Curragh Resources Ltd.
117 Industrial Road
Whitehorse, Yukon
Y1A 2T8

RE: Room and Pillar Review

The following is a brief report of the visit by Chris Page and Jim Mathis to the room-and-pillar operations at Faro during the week of 19 July.

CURRAGH RESOURCES INC.
FARO DEPOSIT
14' x 16' DRIFT
DRILL and BLAST PATTERN

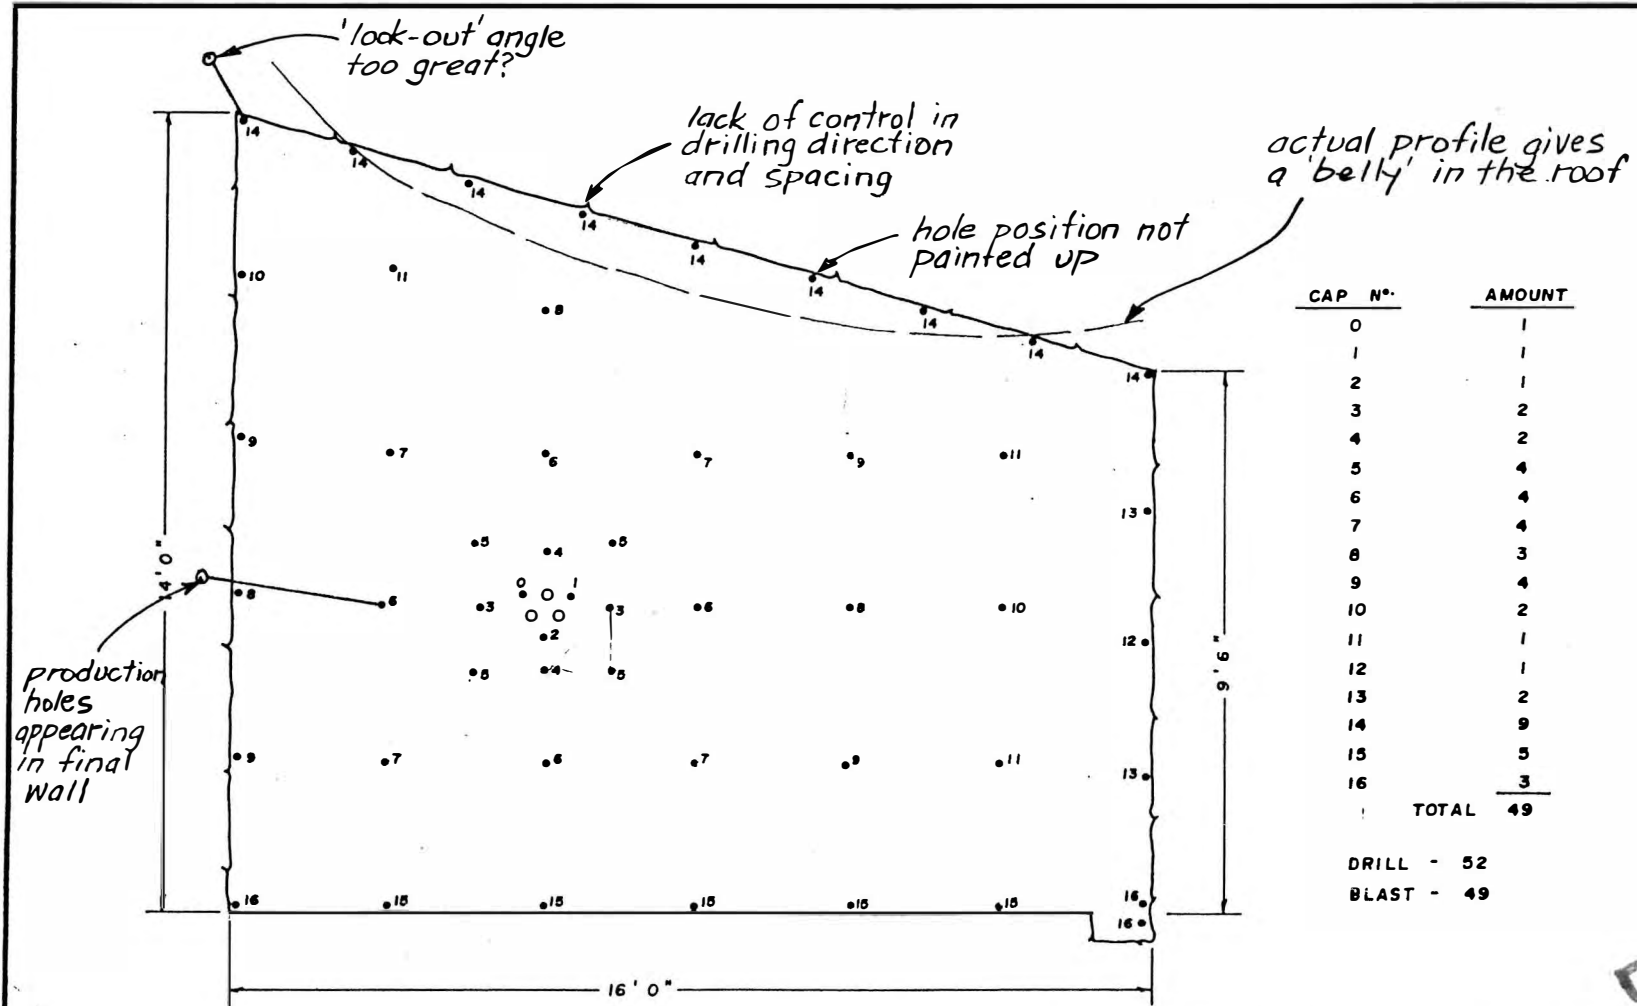
A review of the standard drill layout indicates two problem areas. These are identified in Figure 5 and concern incorrect timing and overcharging of holes close to the roof.
